# CERTIFICATE OF APPROVAL

<b>NOTICE OF NON-COMPLIANCE</b>  Failure to comply with the conditions of this approval is subject to a forfeiture of up to \$500 for each day during which a violation of the Landmarks Commission ordinance (MGO 41) continues.	<b>SITE ADDRESS</b>	740 Jenifer St	
	<b>PROJECT</b>	-Addition to rear of existing structure as proposed -Windows must have a projecting sill	
<b>This permit card must be displayed in a conspicuous location unobstructed from public view.</b>	<b>APPLICANT</b>	Jesse Pfammatter, Craft Builders	
	<b>APPROVED</b>	8/4/25 	
	<b>ISSUED</b>	12/18/25	<b>EXPIRATION</b>   12/18/27
	<b>EXTENSION</b>		<b>PRESERVATION PLANNER:</b> (608) 266-6552

**From:** Craft Builders <admin@craft-builders.com>  
**Sent:** Friday, November 21, 2025 1:18 PM  
**To:** Bailey, Heather  
**Cc:** Jesse Pfammatter  
**Subject:** 740 Jenifer - Exterior Selections, request for COA  
**Attachments:** 740 Jenifer CD Set 9-23 Exterior Light and Mech.pdf

Addition/Interior

EXTERIOR LIGHT AND MECHANICAL PLAN

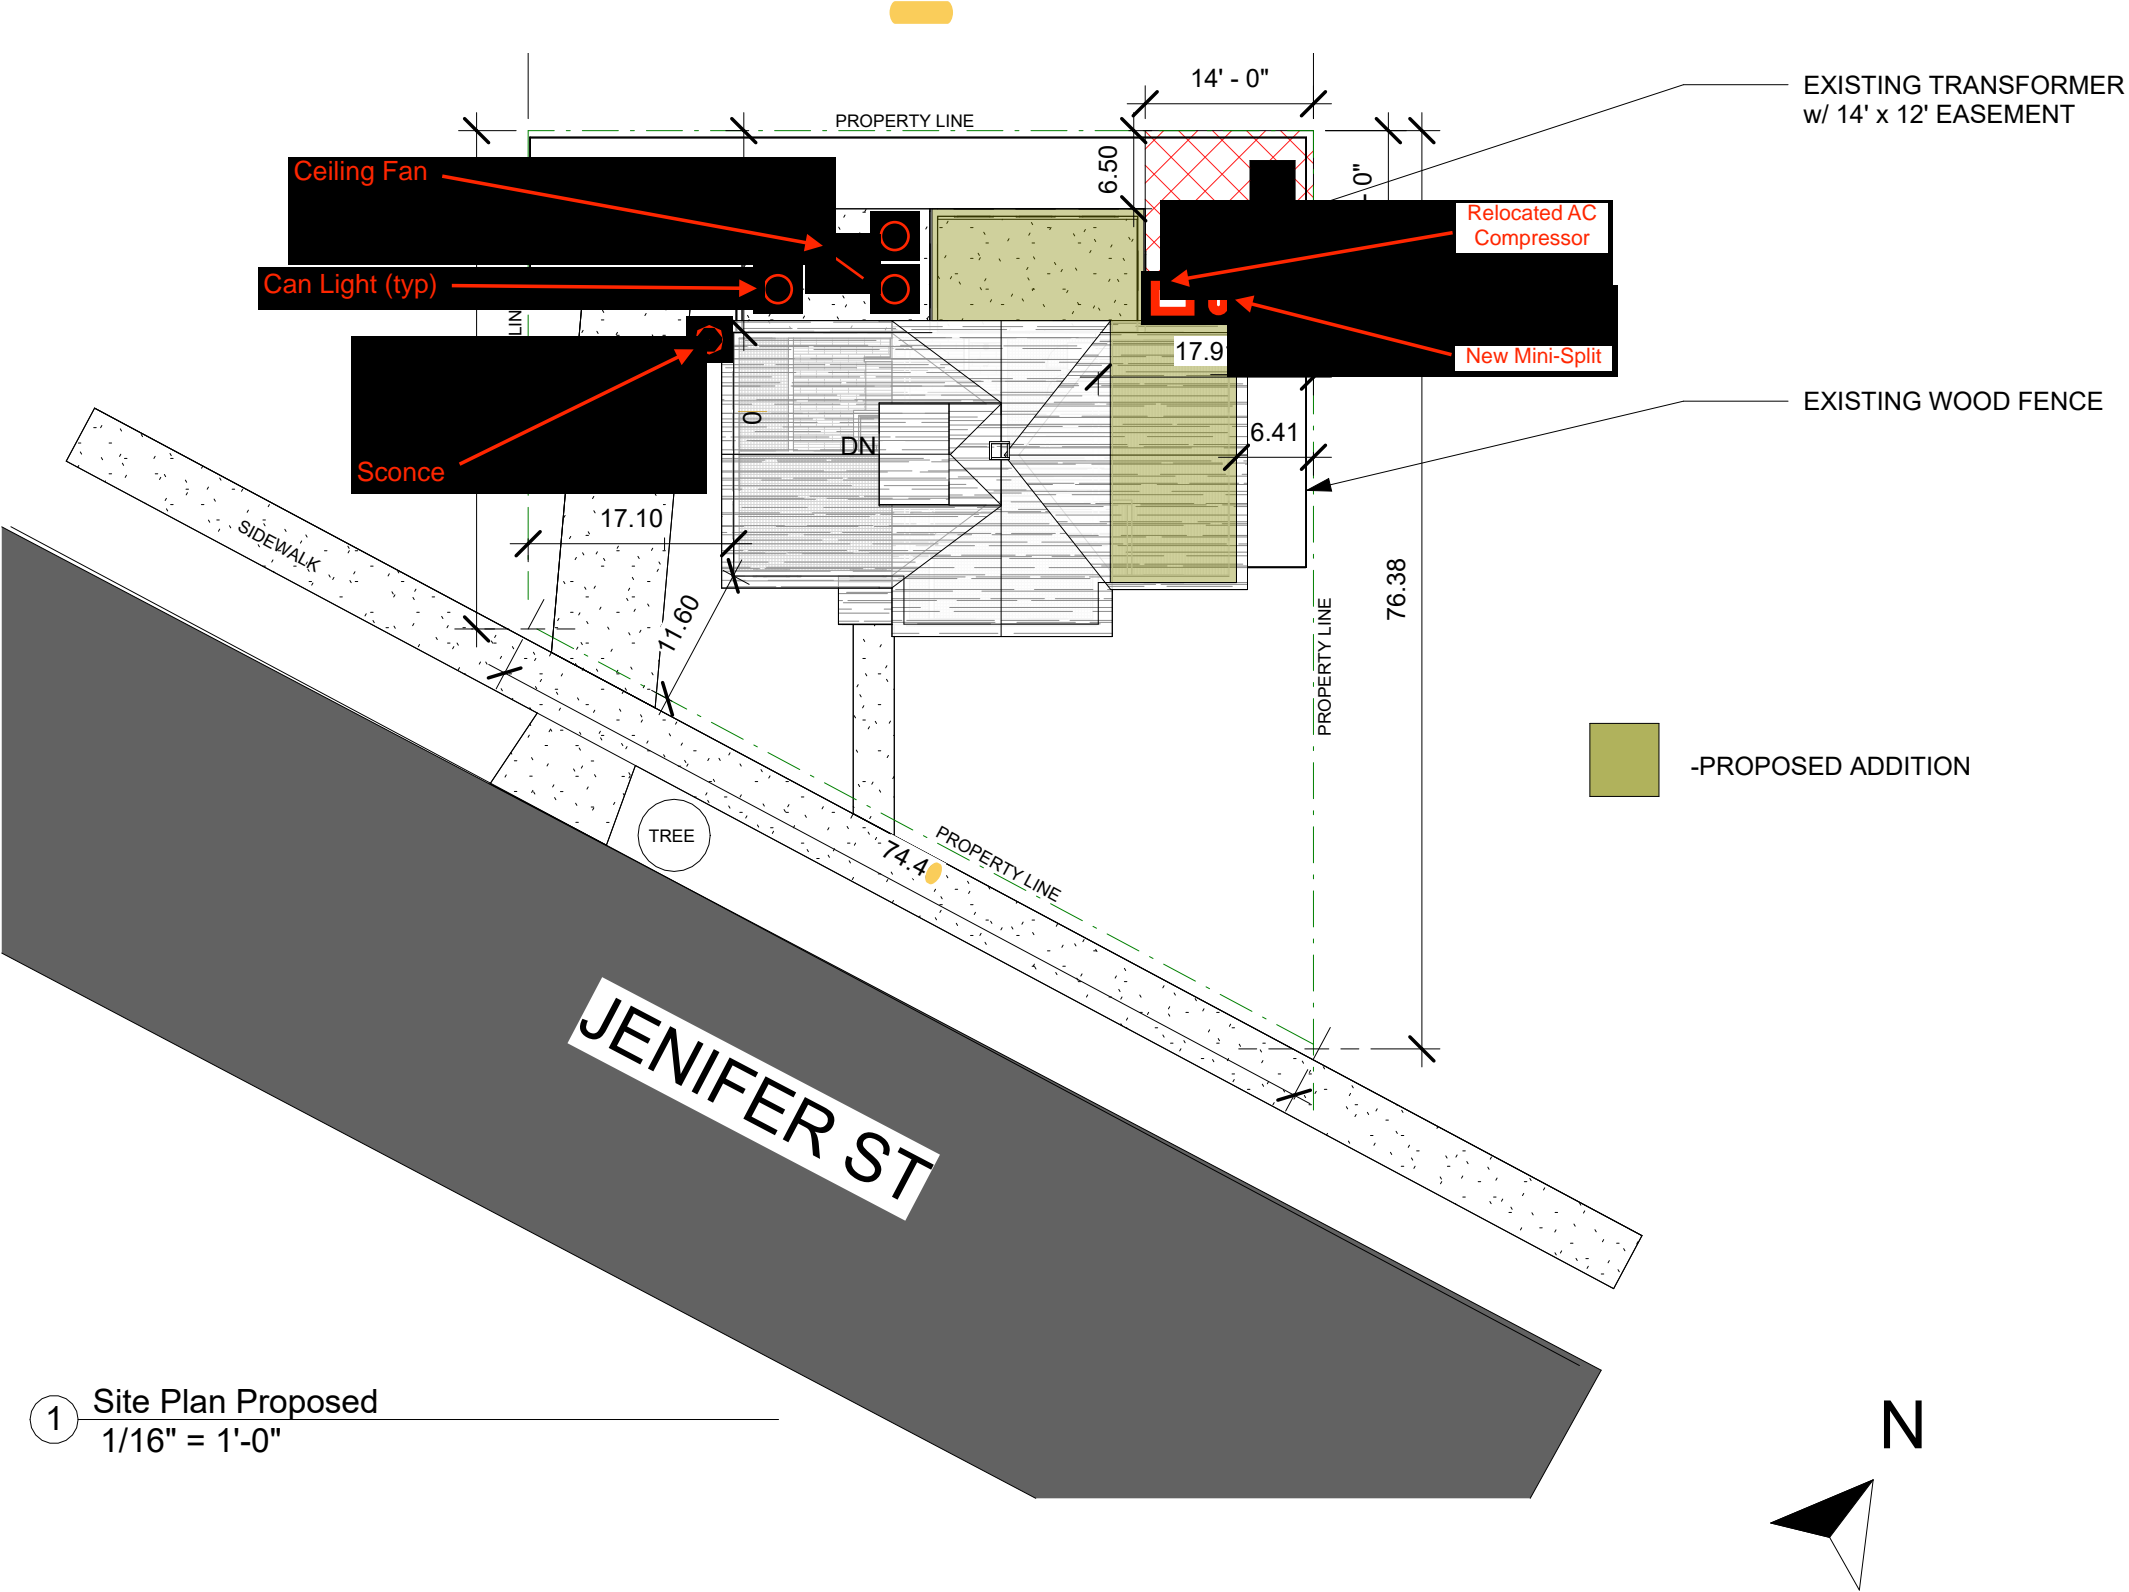
**3. New exterior light fixtures and new mechanicals to be approved by staff**

See attached Exterior Light and Mechanical plan for locations of AC and mini-split compressors.
